ADDENDUM NO. 2

March 1, 2022

**TIMOTHY BALL ELEMENTARY SCHOOL ADDITIONS, RENOVATIONS,
AND RELATED WORK
Crown Point, IN 46307**

This Addendum forms a part of and modifies the Bidding Requirements, Contract Forms, Contract Conditions, the Specifications, and the Drawings dated February 7, 2022 by Gibraltar Design. Acknowledge receipt of the Addendum in the space provided on the Bid Form. Failure to do so may subject the Bidder to disqualification.

PROJECT
**TIMOTHY BALLEES ADDITION
AND
RENOVATIONS**
CROWN POINT COMMUNITY
SCHOOL CORPORATION
CROWN POINT, INDIANA

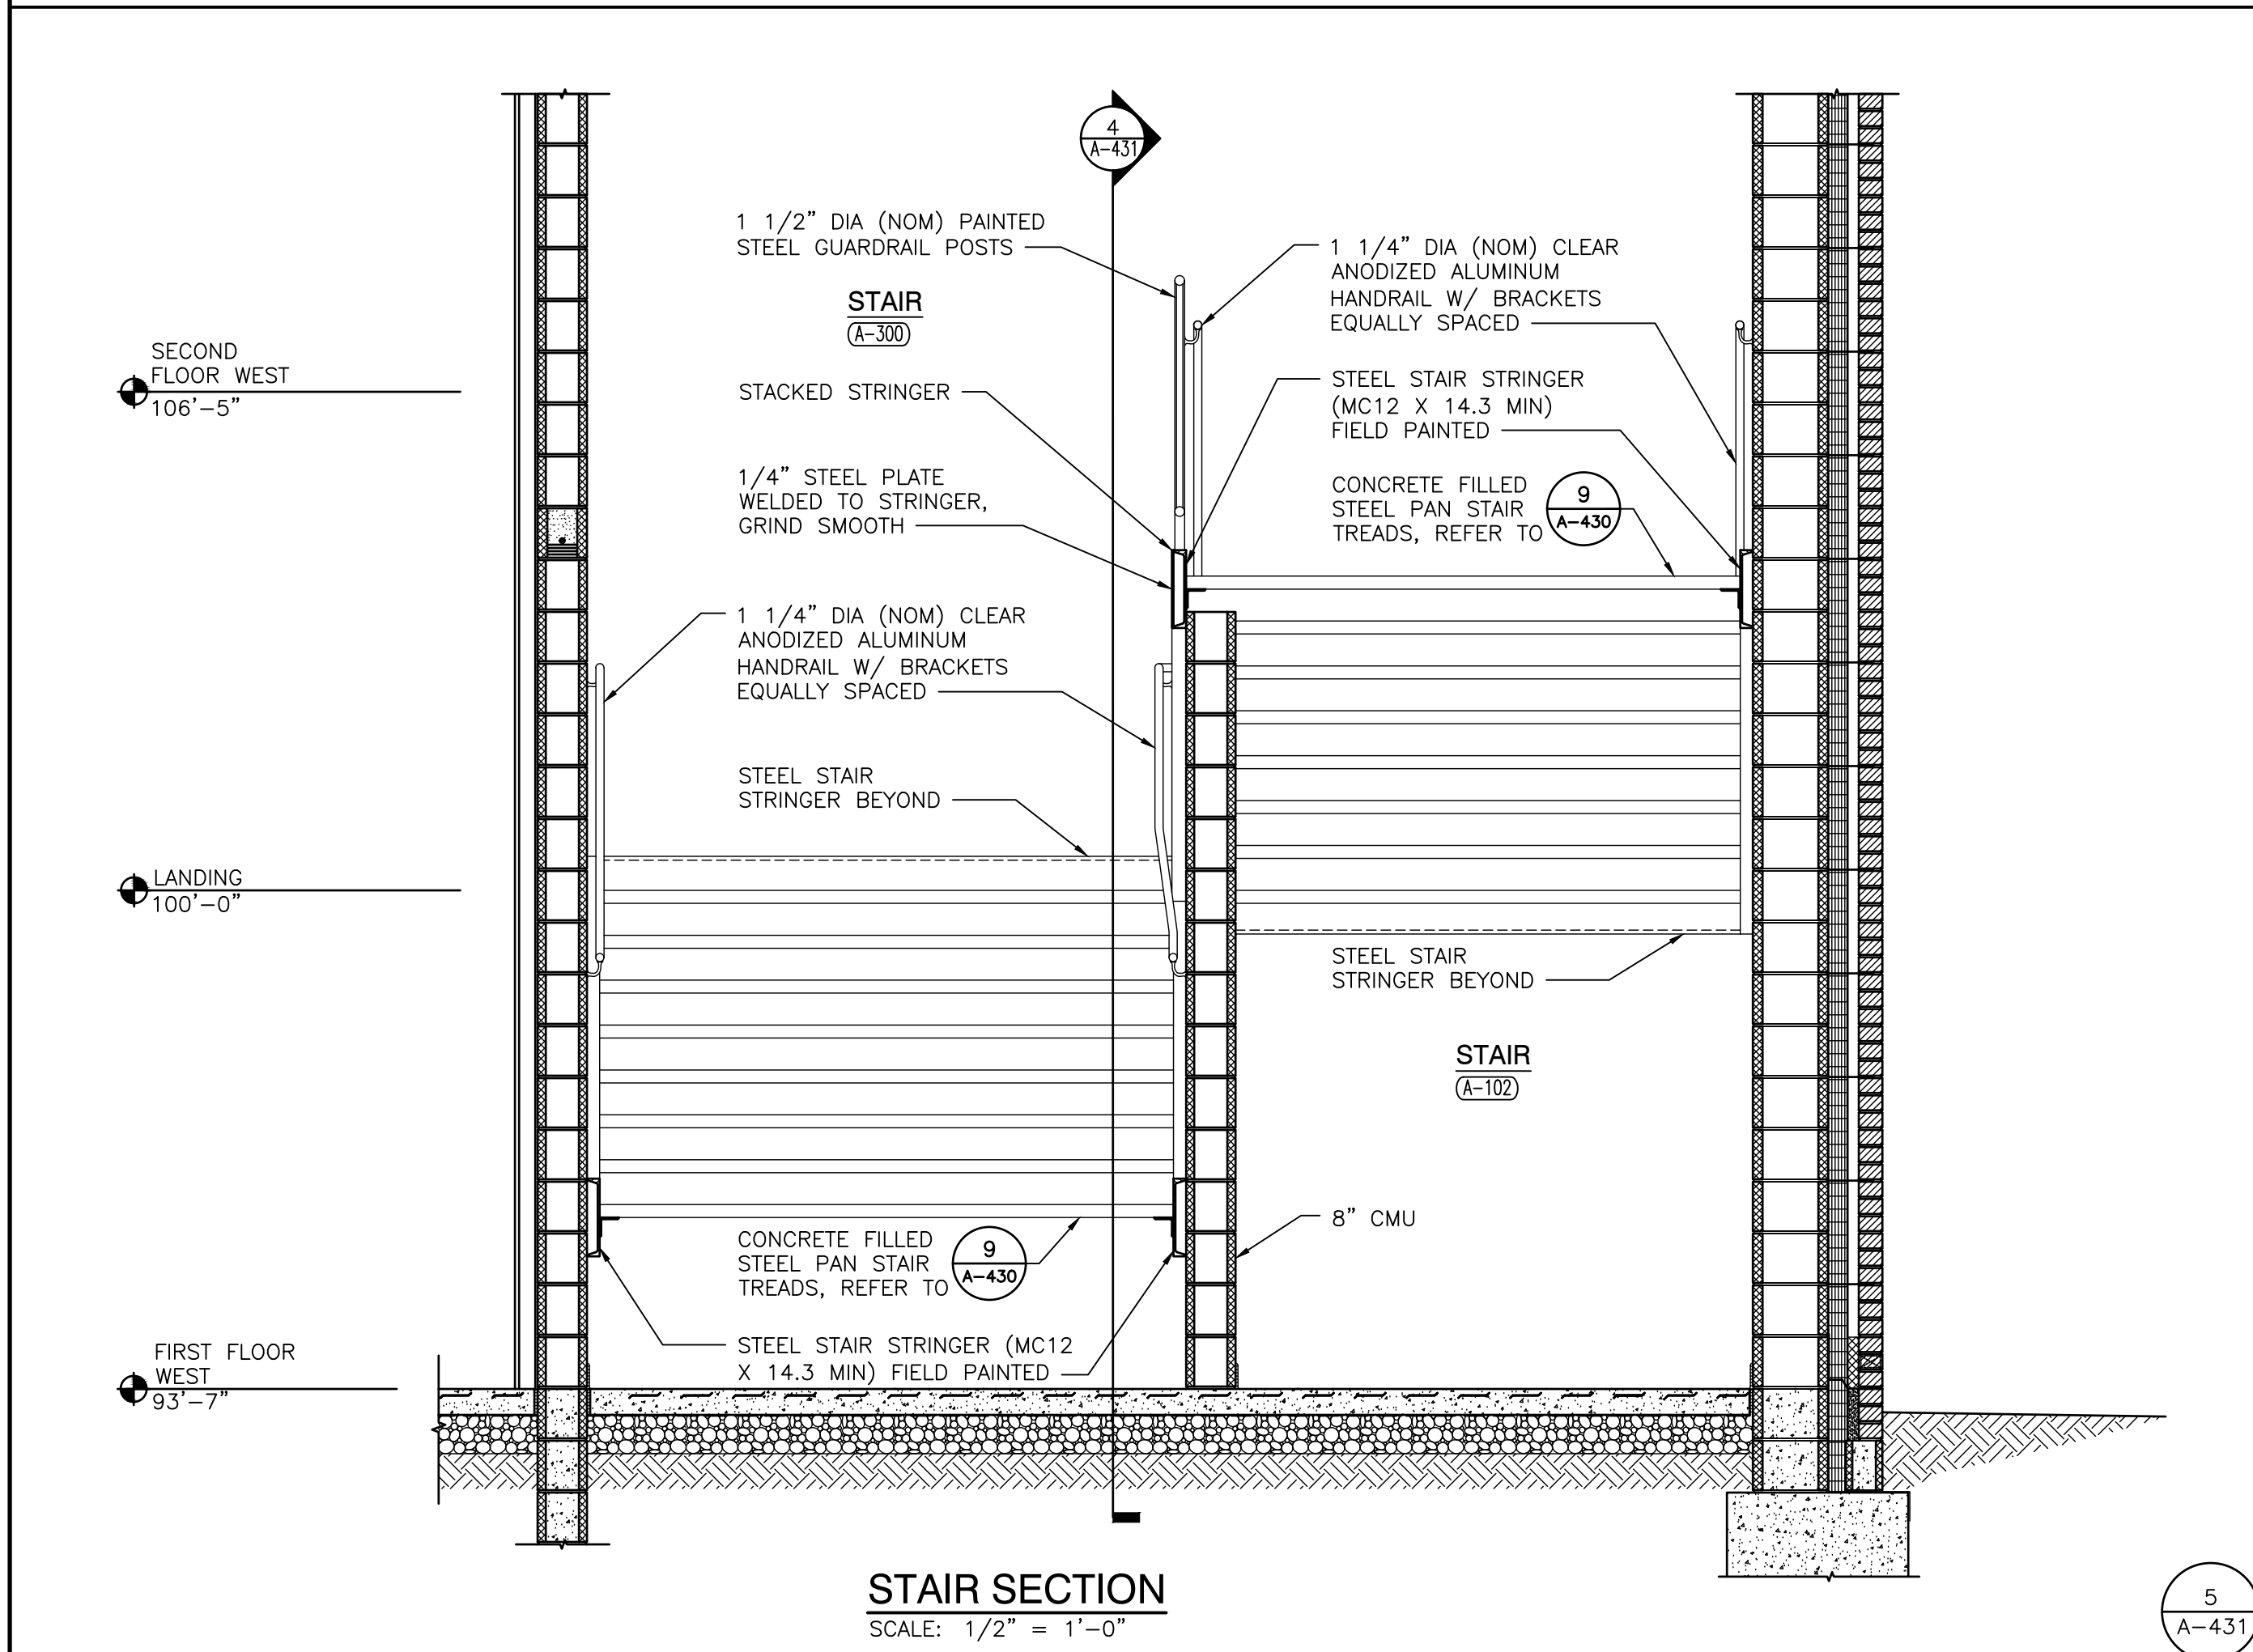
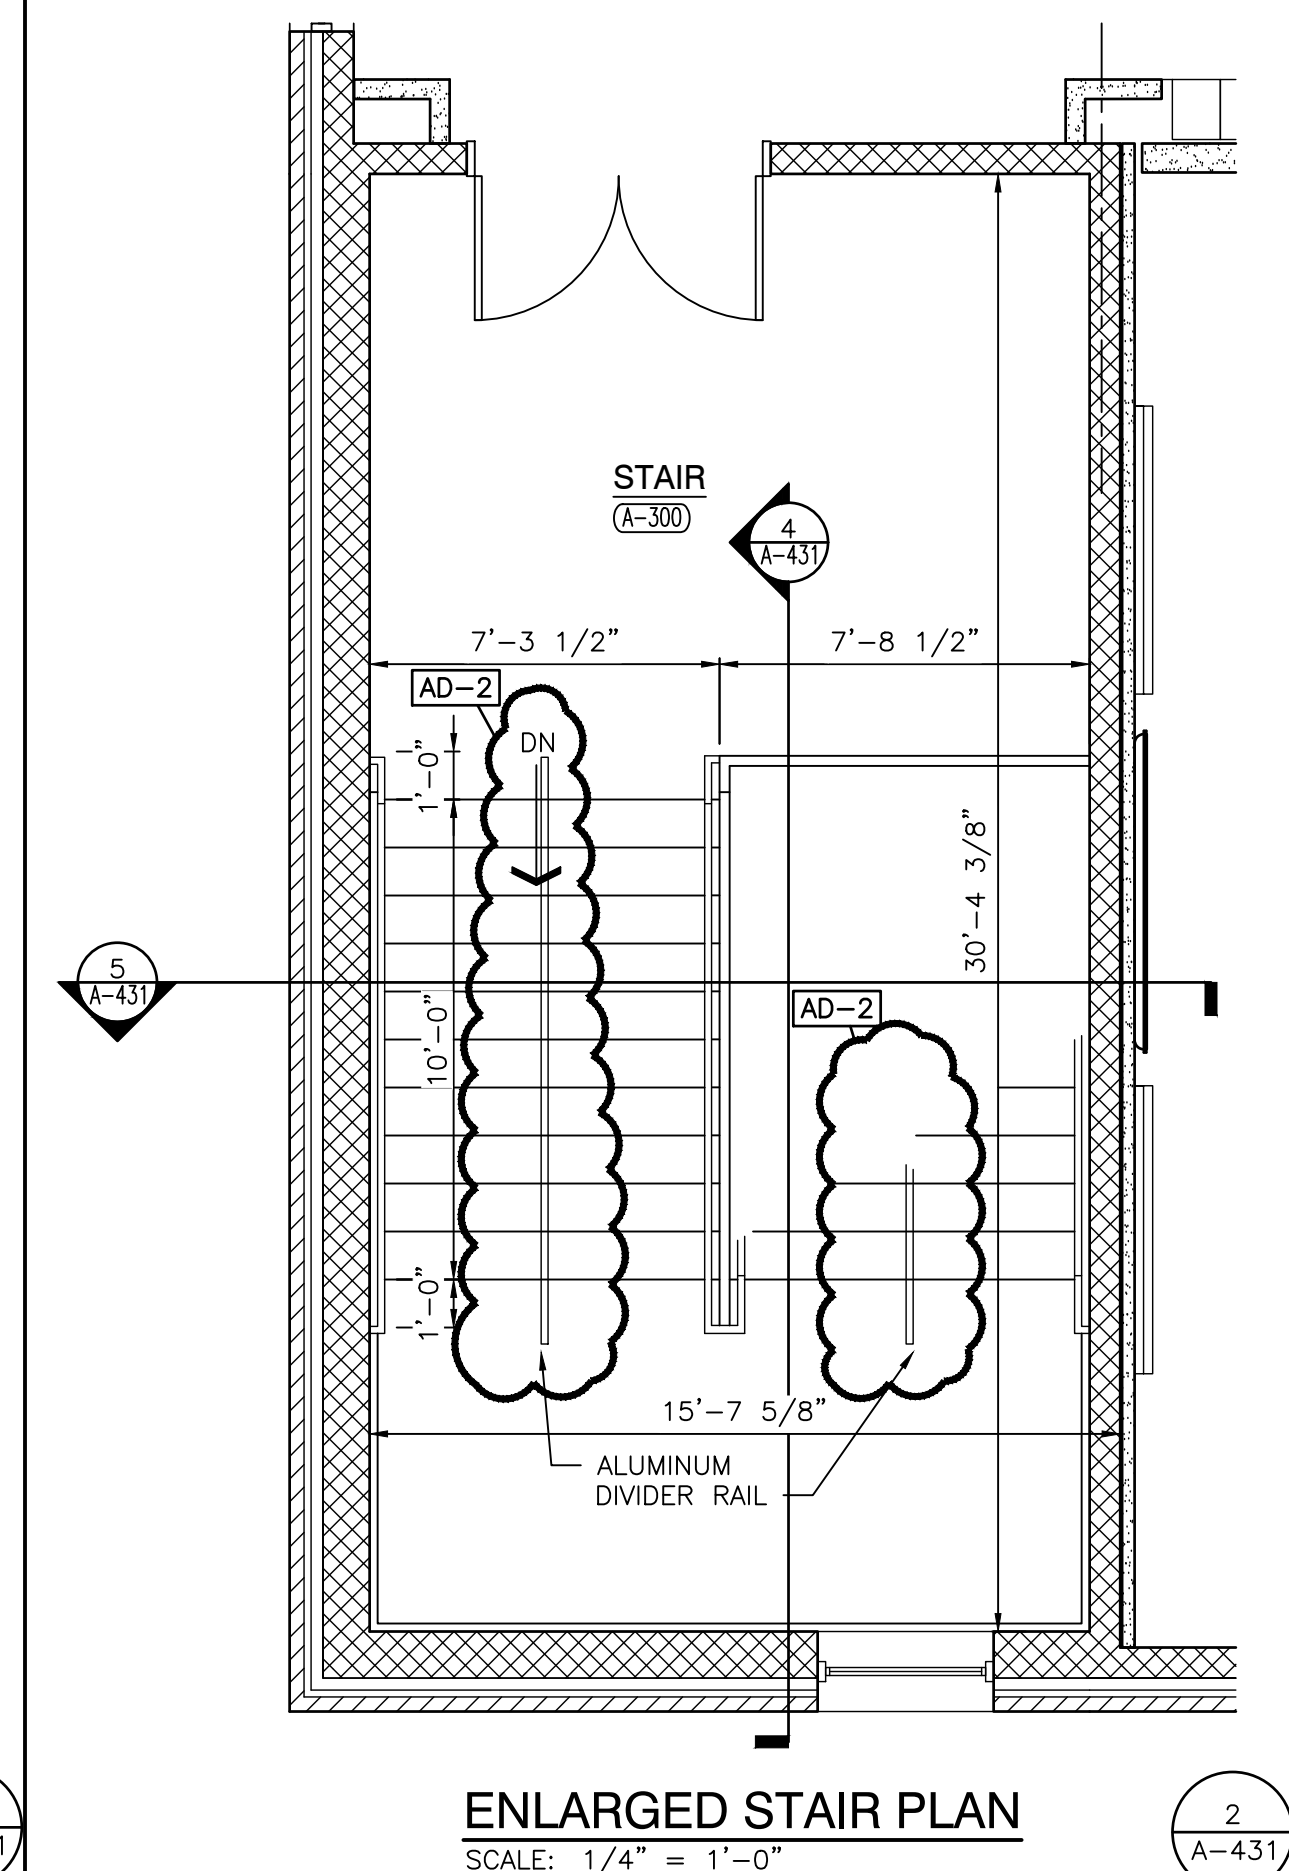
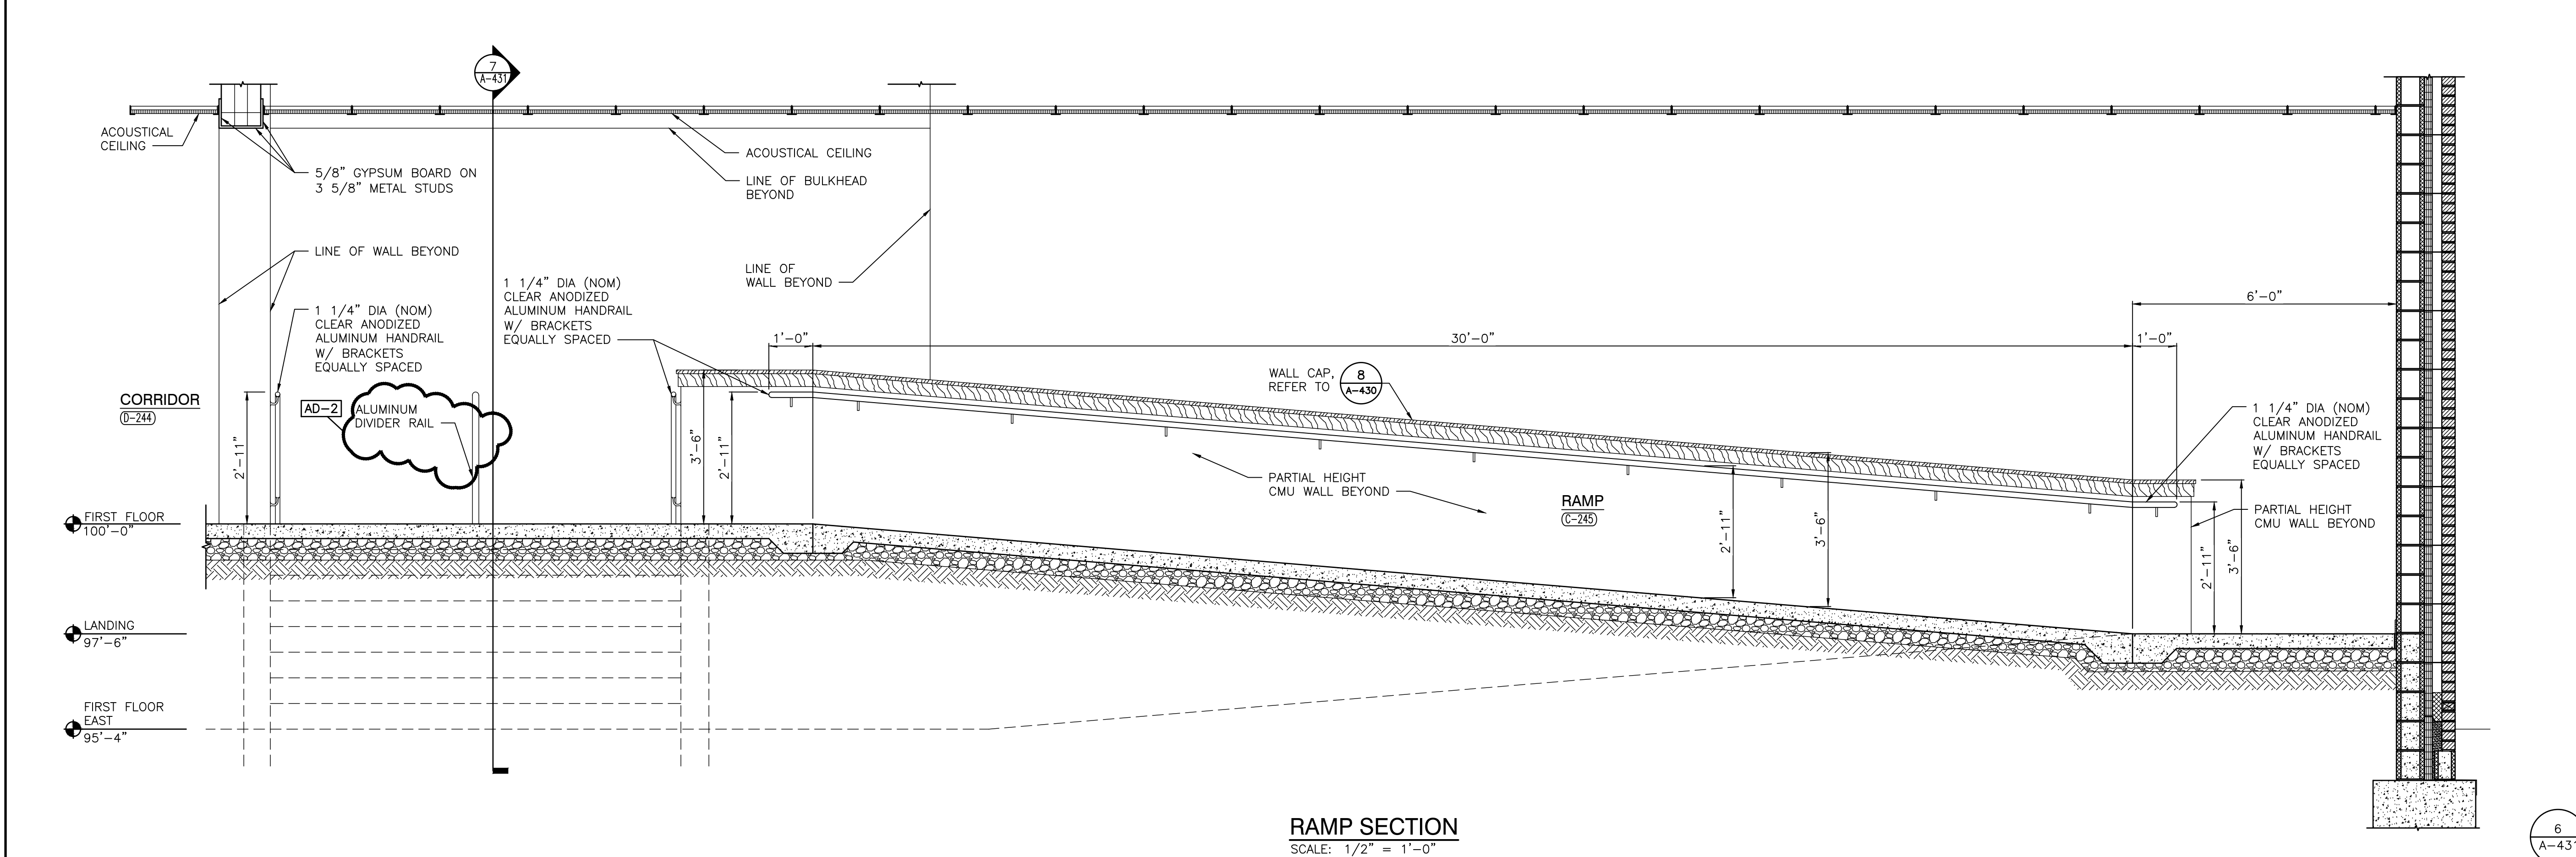
13. Sheet A-416

1. Revise Wall Section 3/A-416.
2. Refer to Section Drawing for clouded dimension revisions in multiple locations.
